PROPOSED MINOR AMENDMENTS

NOTE: THESE PROPOSED MINOR AMENDMENTS RELATE TO AN ORIGINAL DESIGN BY CHRIS DYSON ARCHITECTS [PLANNING APPROVAL REF: 2019/5443/P] WITH MINOR AMENDMENTS BY MDA & MILK STUDIO [PLANNING APPROVAL REF: 2020/3584/P] AND RELATED LISTED BUILDING APPROVALS 2019/5469/L AND 2020/3585/L

12 Keats Grove,
Hampstead,
London, NW3 2RN

Proposed Second Floor

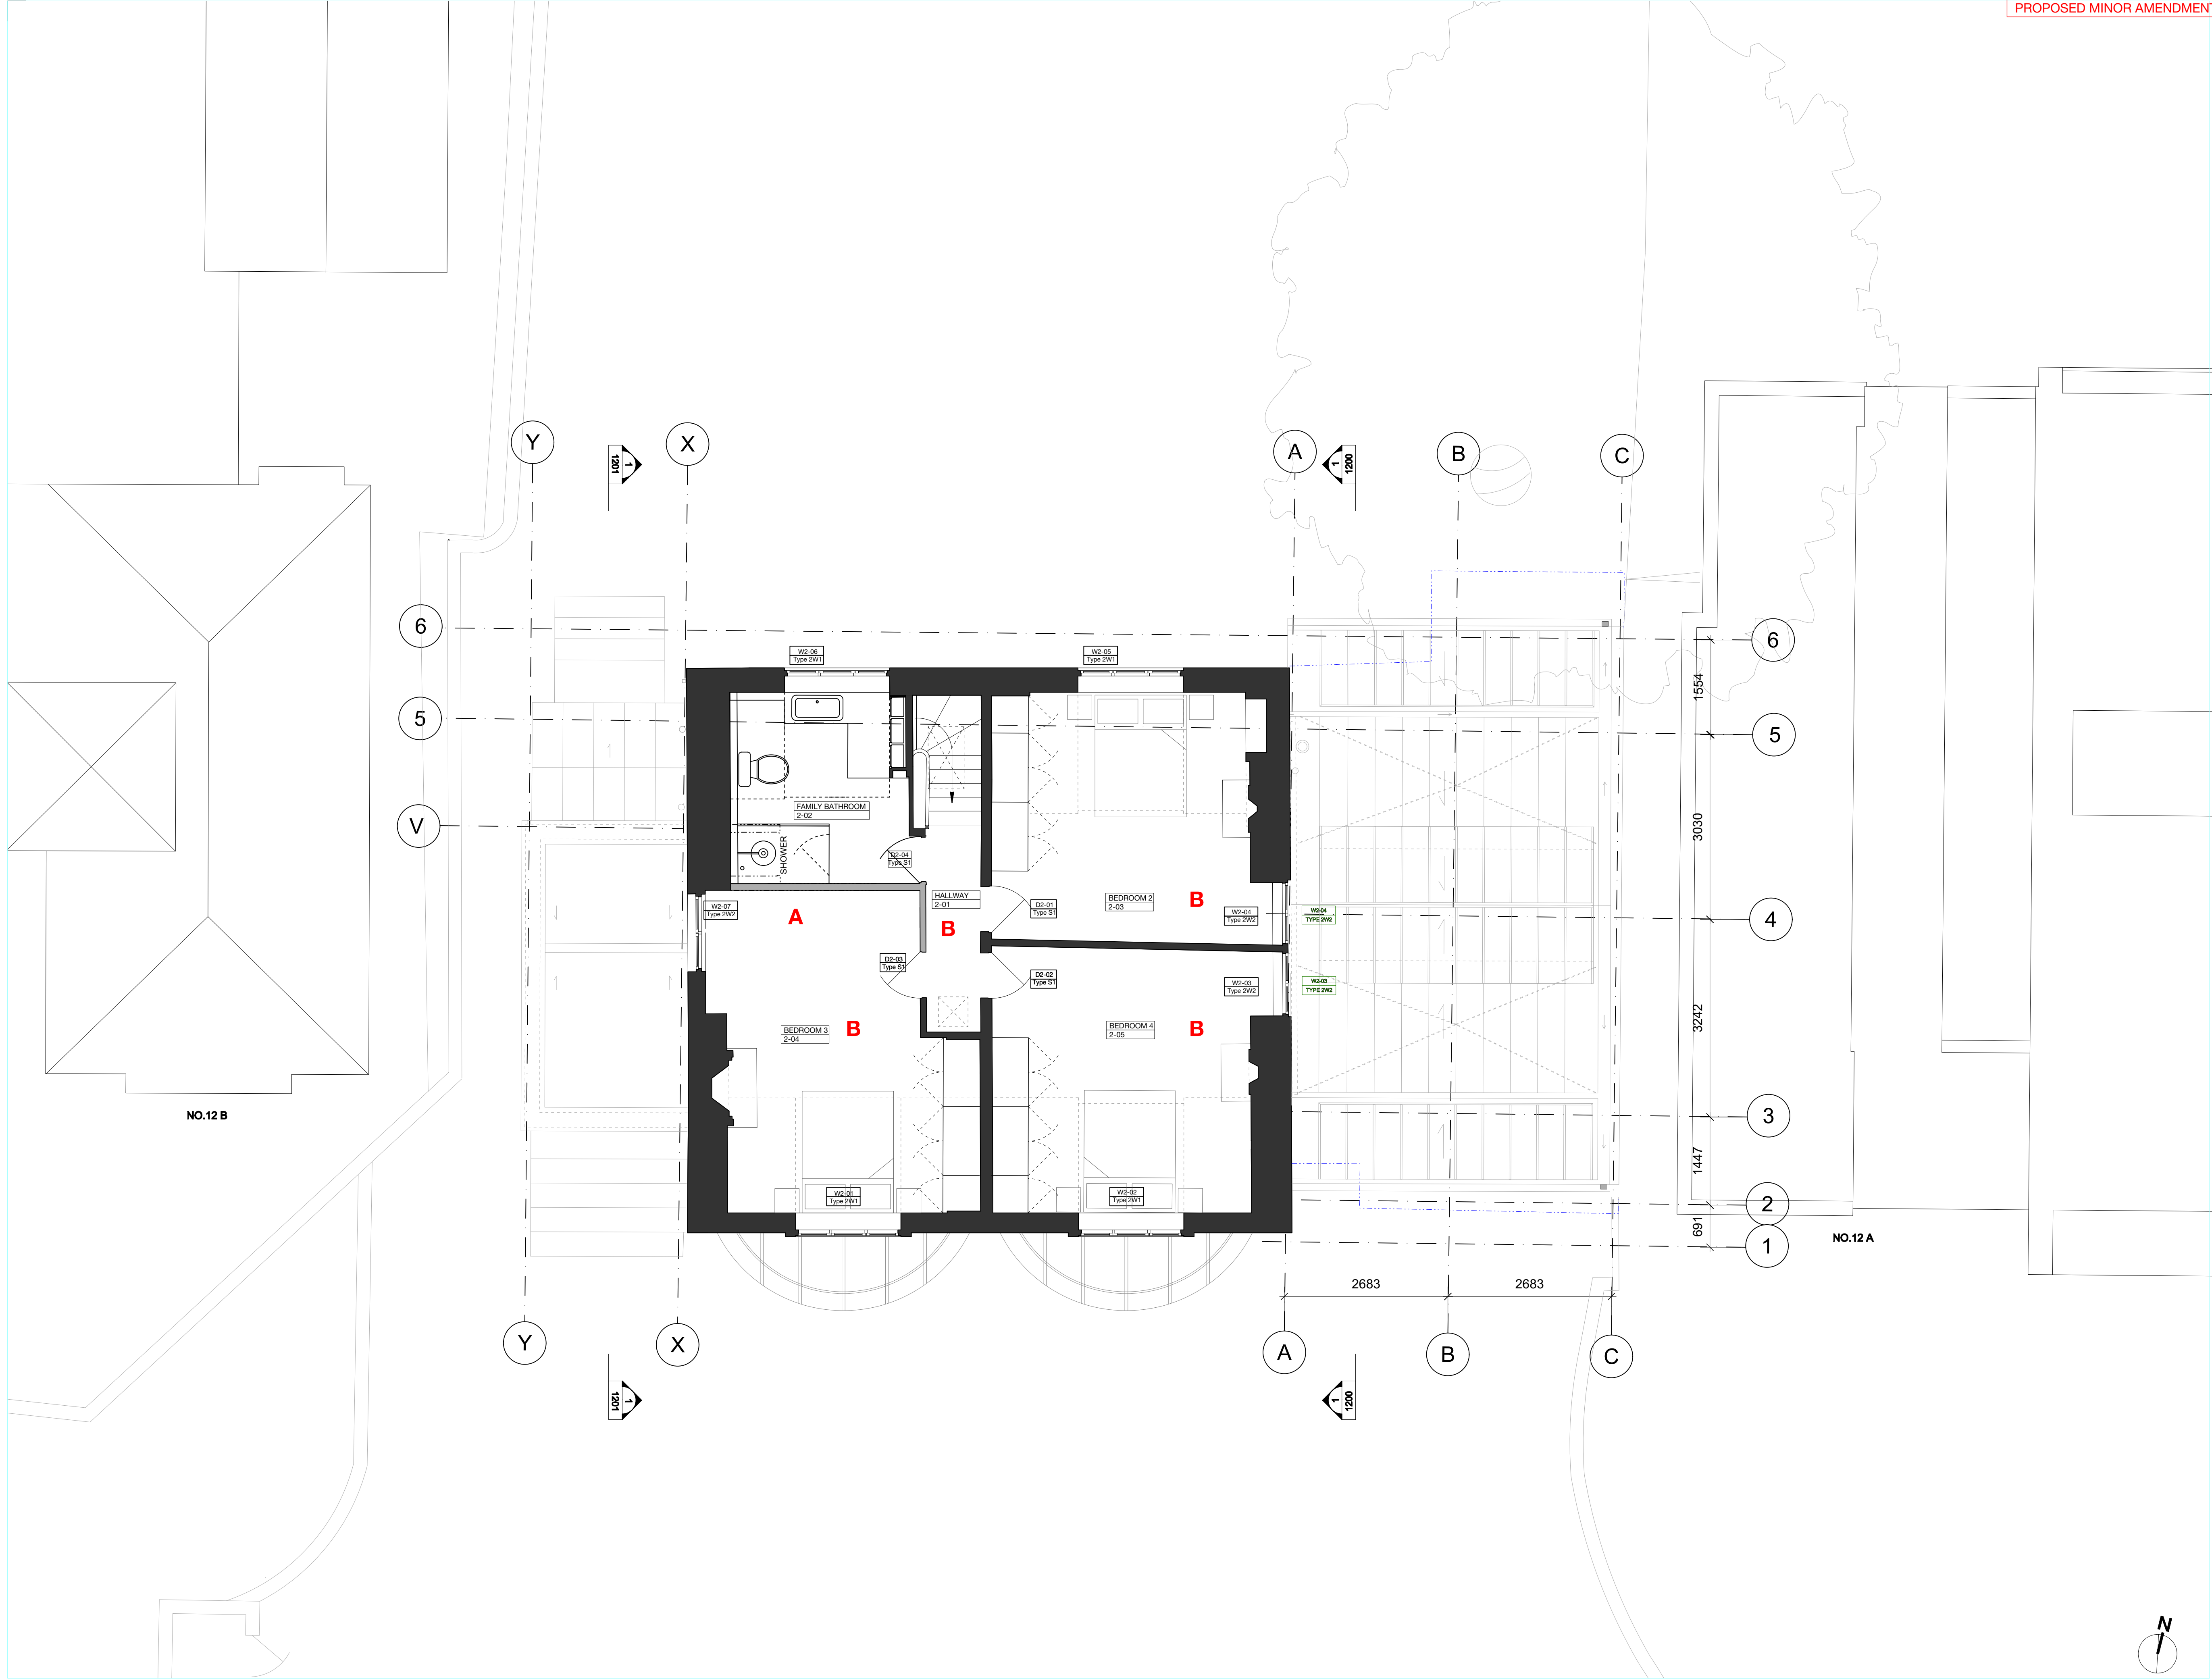
A: Retain current layout of shower room wall so it does not cut window.

B: Replace chipboard flooring with historically sympathetic aged oak wide board flooring.

1 East Elevation at Boundary
Scale: 1:50

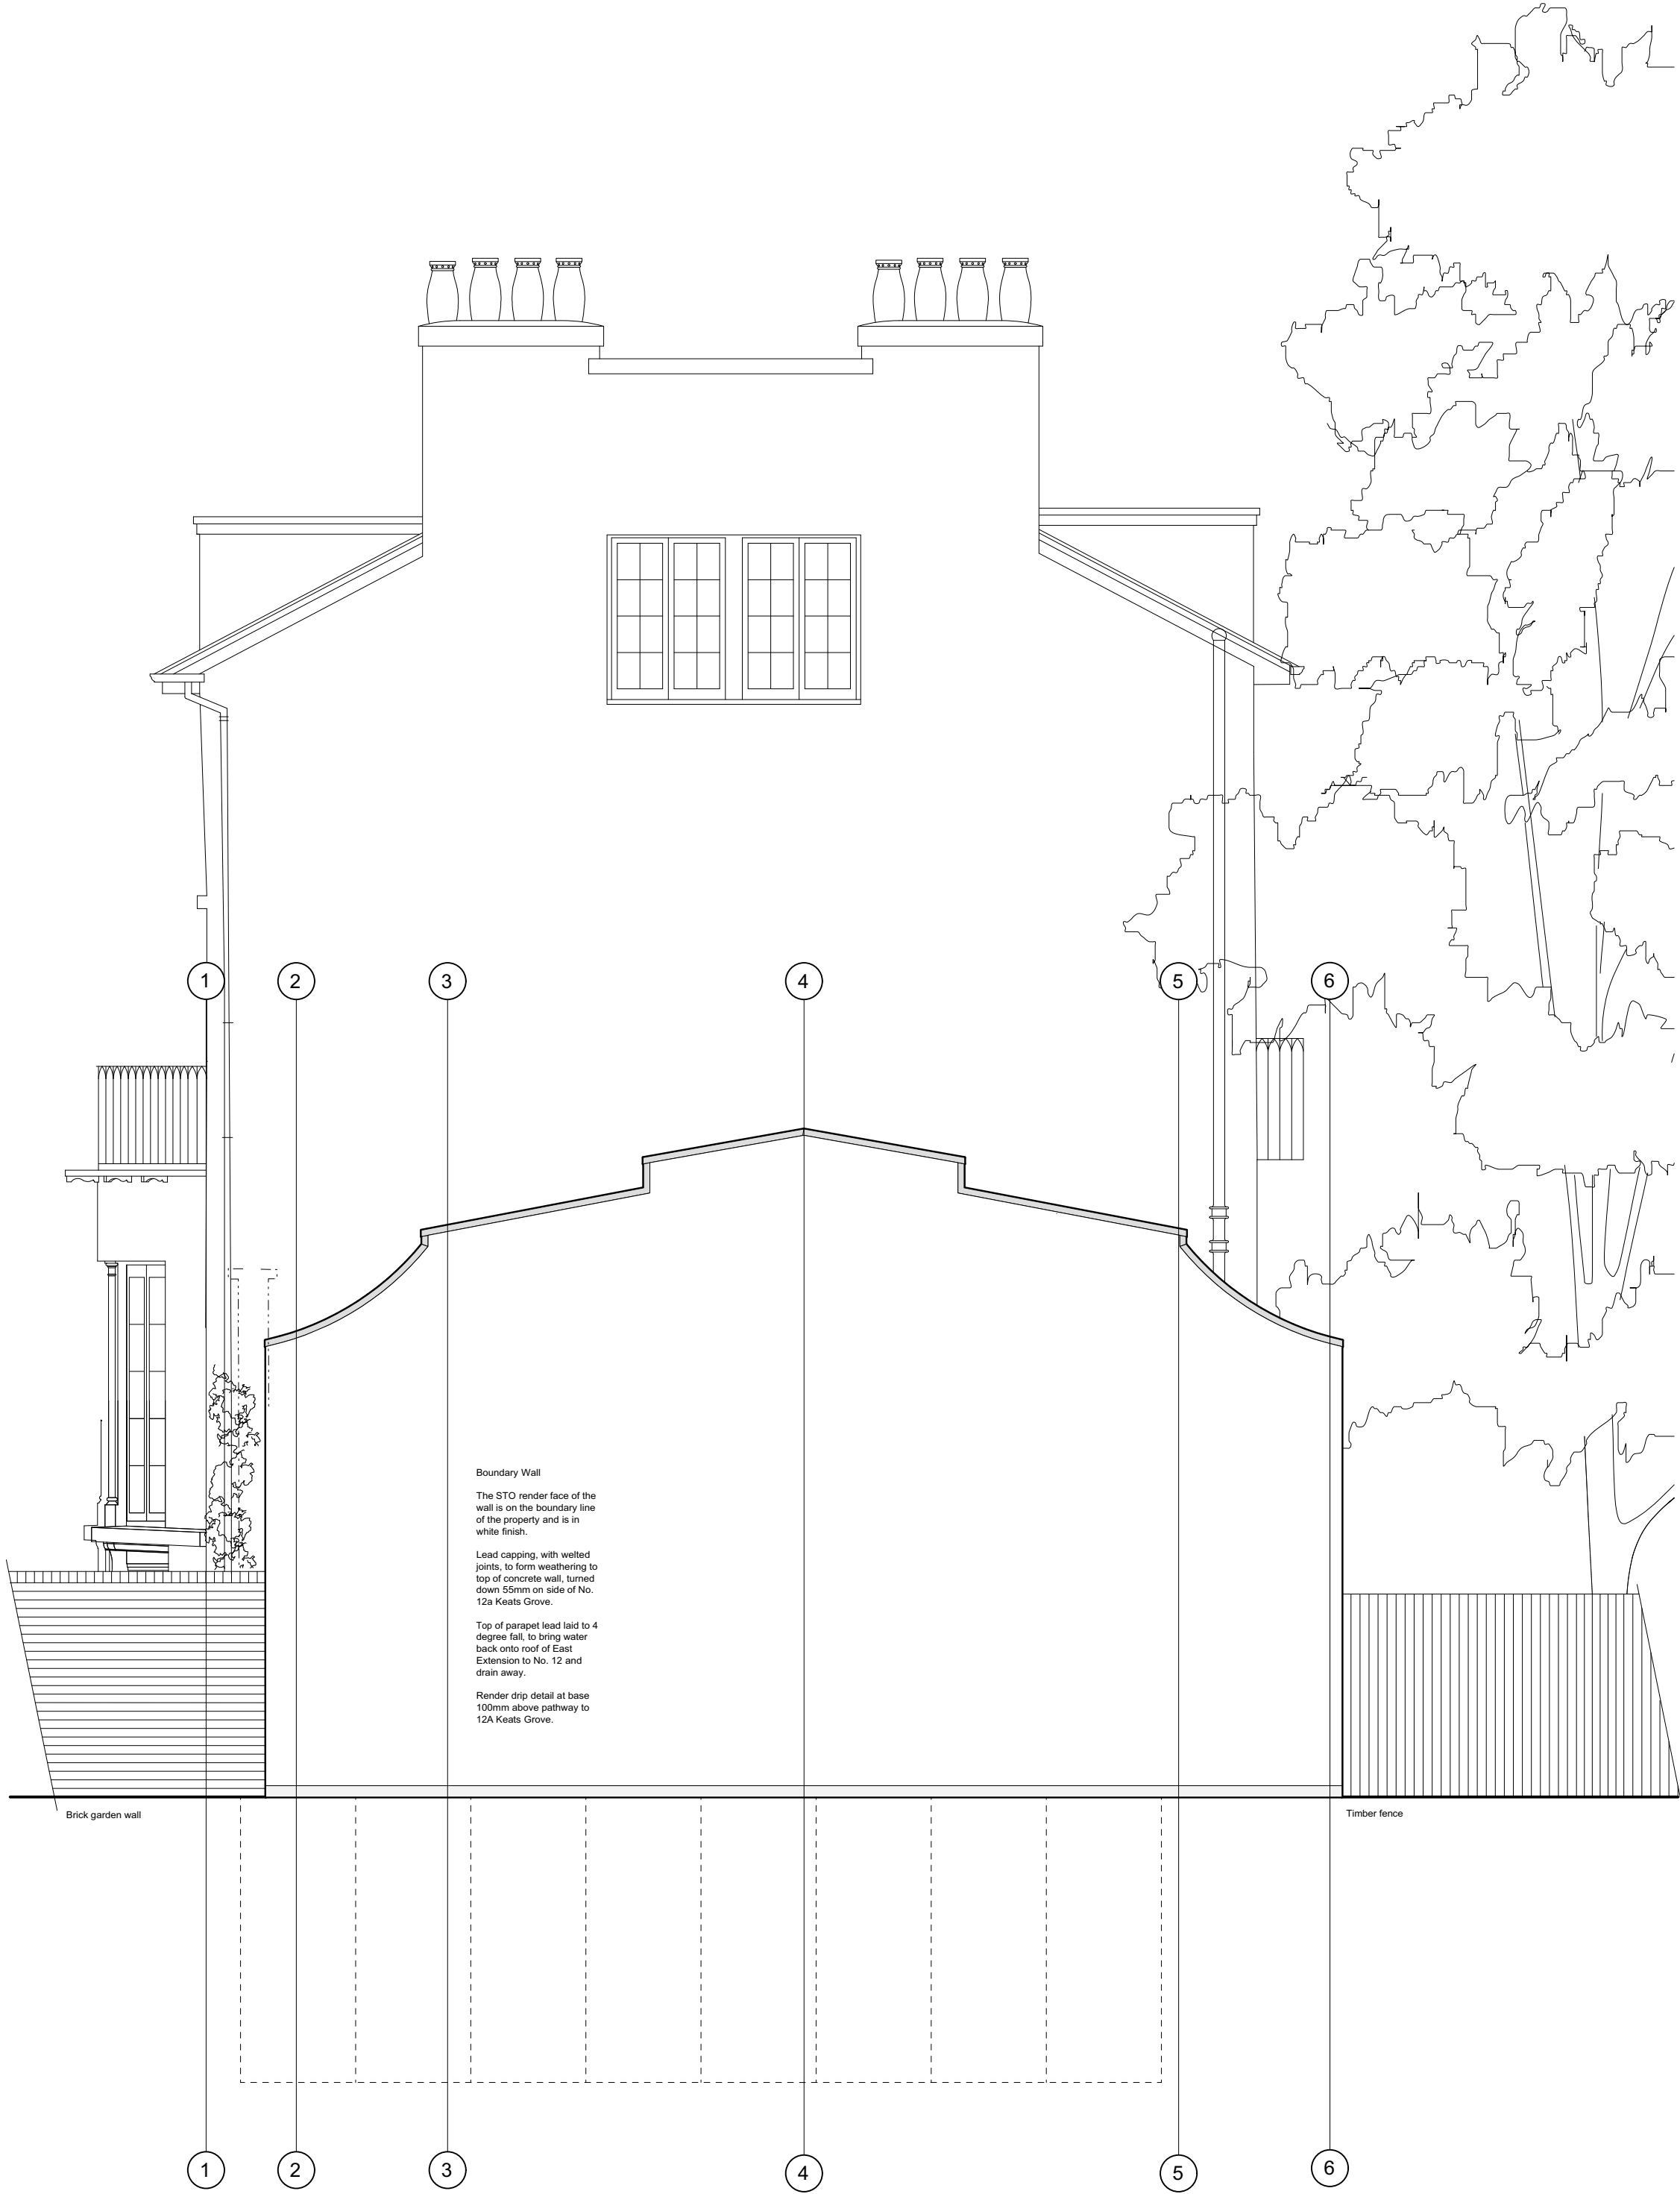
A: Banking up of landscape shown in approved scheme removed in order to avoid major retaining structures at boundary and to prevent damage in the root protection area of the tree as raising the soil level over existing tree roots can have a great effect on the future survival of existing trees.

When soil or any type of fill is placed over the existing root system, it causes a reduction in the oxygen supply to the roots and slows down the rate of gas exchange between the roots and the air.

1 Proposed East Extnsion: Section BB
Scale: 1:50

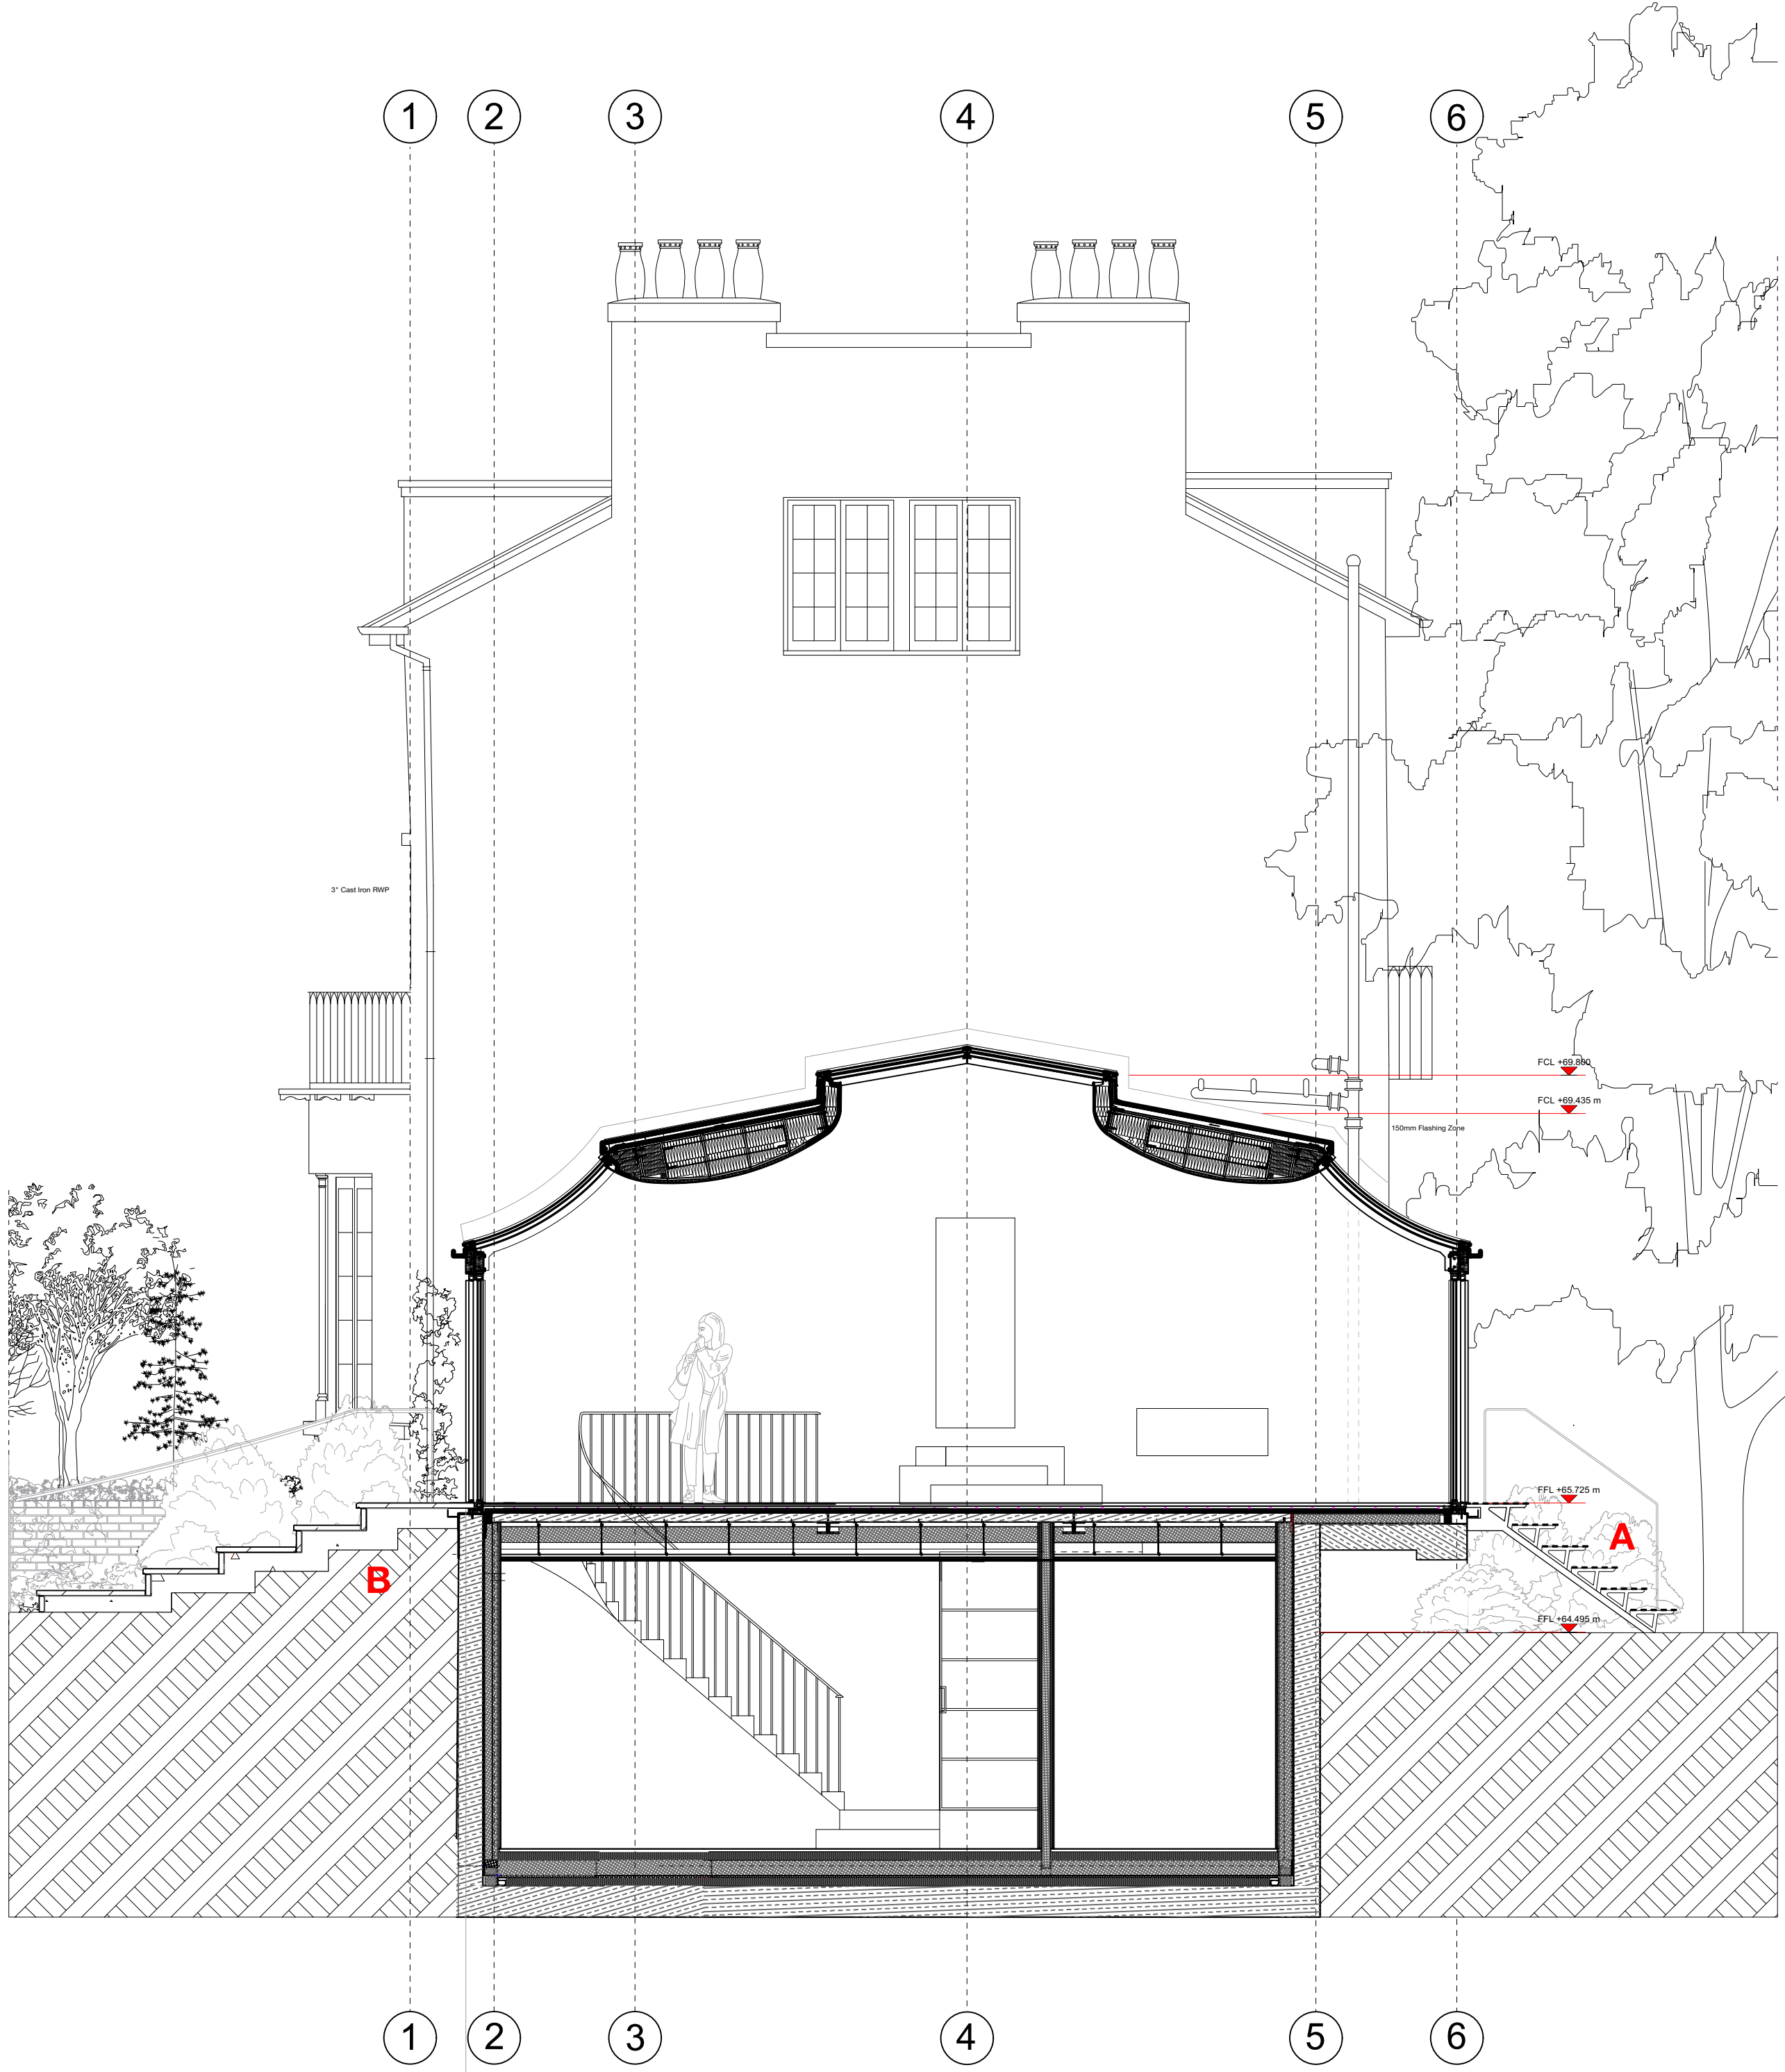
A: Banking up of landscape shown in approved scheme removed in order to avoid major retaining structures at boundary and to prevent damage in the root protection area of the tree as raising soil level over existing tree roots can have a great effect on the future survival of existing trees.

When soil or any type of fill is placed over the existing root system, it causes a reduction in oxygen supply to the tree roots and slows down the rate of gas exchange between roots and the air.

B: Banking up earth only in area under stairs to avoid major retaining works at boundary.
